# HISTORIC AND DESIGN REVIEW COMMISSION

**HDRC CASE NO:** 2021-335  
**ADDRESS:** 216 N MESQUITE ST  
**LEGAL DESCRIPTION:** NCB 583 BLK 8 LOT 12  
**ZONING:** RM-4, H  
**CITY COUNCIL DIST.:** 2  
**DISTRICT:** Dignowity Hill Historic District  
**APPLICANT:** Ofelia Delgado  
**OWNER:** Ofelia Delgado  
**TYPE OF WORK:** Front porch column replacement  
**APPLICATION RECEIVED:** July 02, 2021  
**60-DAY REVIEW:** Not applicable due to City Council Emergency Orders  
**CASE MANAGER:** Edward Hall

The applicant is requesting a Certificate of Appropriateness for approval to replace the existing, four, wrought iron columns with four, round columns.

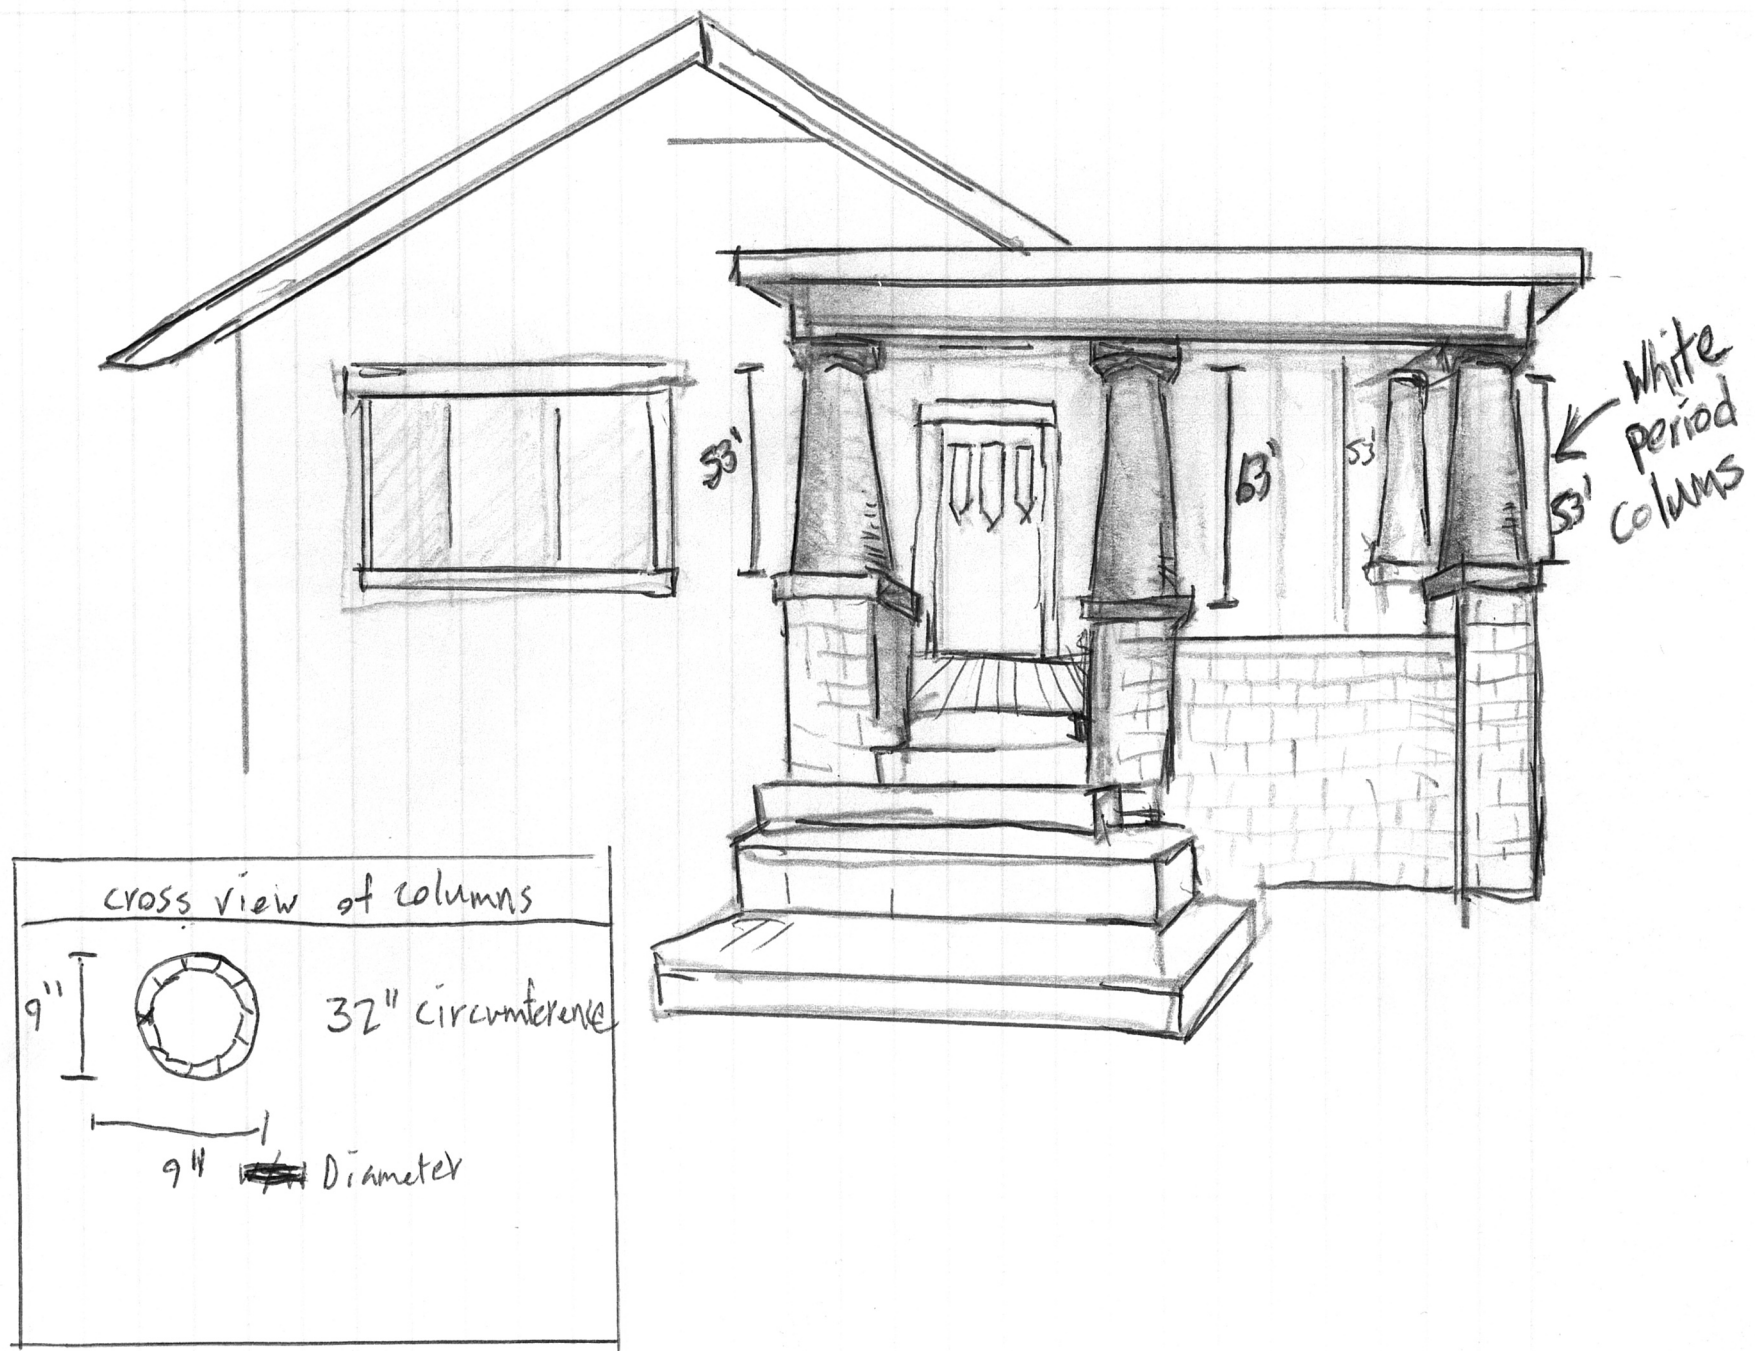
- a. The historic structure at 216 N Mesquite was constructed circa 1910 in the Craftsman style, and first appears on the 1912 Sanborn Map. At this time, the applicant is requesting a Certificate of Appropriateness for approval to replace the existing, four, wrought iron columns with four, round columns.
- b. COLUMN REPLACEMENT – Per the Guidelines for Exterior Maintenance and Alterations 7.B.iii., replacement elements should be designed to be simple so as to not distract from the historic character of the building. Additionally, new elements and details should not be added that create a false historic appearance. Staff finds that square tapered or square columns with capital and base trim would be most appropriate and consistent with the Guidelines.

Staff recommends column replacement with the stipulation that tapered or square columns with capital and base trim be installed. The existing, brick pediment are to remain unmodified.
